# Rezoning Transportation Analysis

Petition Number: #2022-048

## Revision Log:

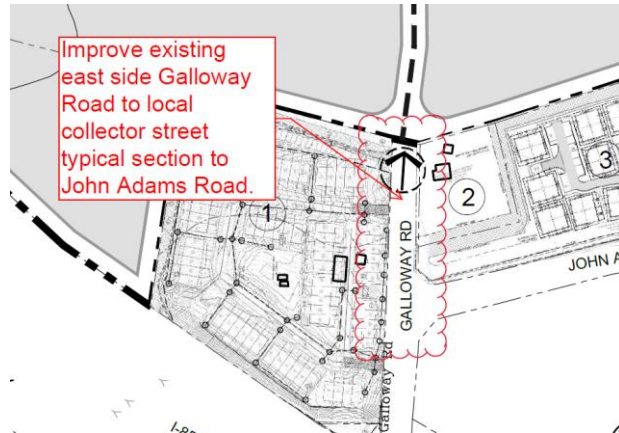
A Traffic Impact Study (TIS) is necessary for the complete review of this petition due to the site generating more than 2,500 daily trips. The petitioner submitted the Draft TIS Scoping Package on August 16, 2022, and CDOT approved the scoping package on August 31, 2022. **The Revised TIS was submitted to CDOT on January 13, 2023, and is currently under review by CDOT.**

Staff will receive the petition and begin review, but the public hearing will not be scheduled until the TIS is approved to allow for the minimum time necessary for CDOT to review the study and reach agreement with the petitioner on the required transportation commitments. Any agreed upon commitments shall be included on the last site plan submitted no fewer than 4 weeks prior to the public hearing. Therefore, additional traffic mitigation comments may be forthcoming once the TIS is approved by CDOT (and NCDOT).

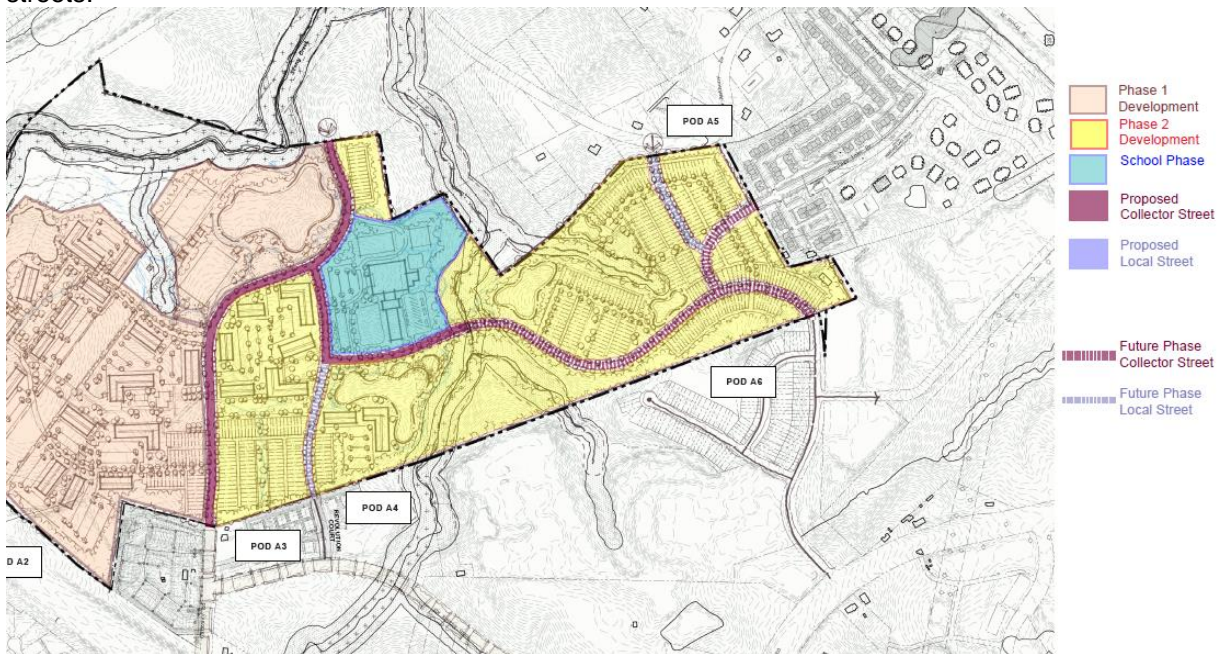
~~2. Outstanding Comment from 08-25-22: Revise site plan and conditional note(s) to commit to improving the existing Galloway Road stub to John Adams to the local collector street typical section per U-07.~~

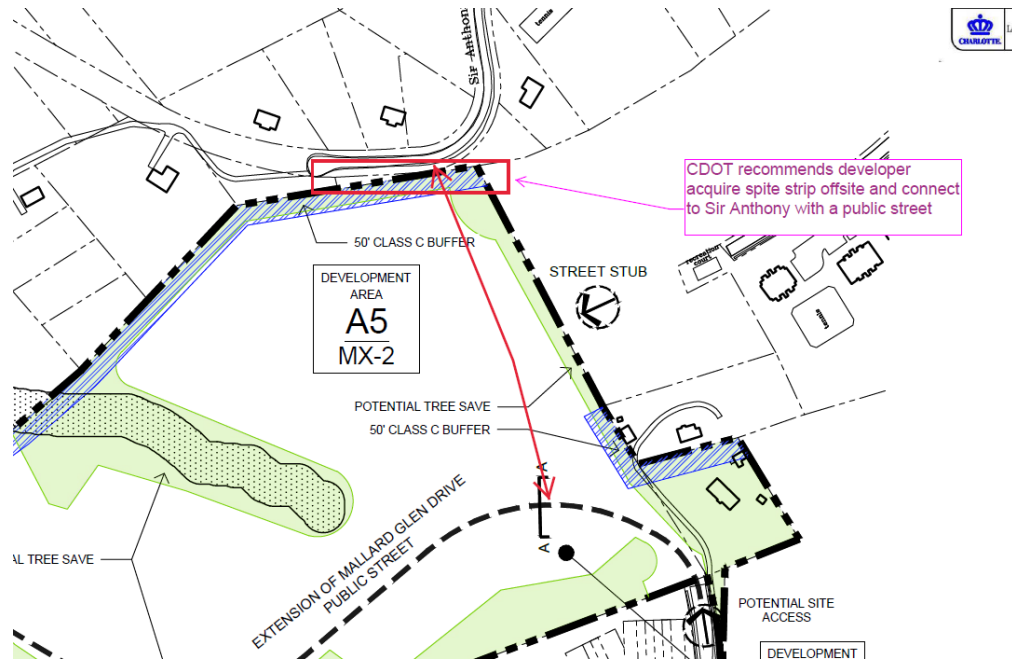
- ~~4. Add conditional Lighting Note for petitioner to coordinate with CDOT Lighting, Bruce Horltd (704-589-5836 or Bruce.Horltd@charlottenc.gov), prior to permitting of lighting fixtures on public roadways.~~
- ~~5. **CDOT RECOMMENDATION:** CDOT recommends the petitioner commit to providing a public street connection to Sir Anthony Drive.~~
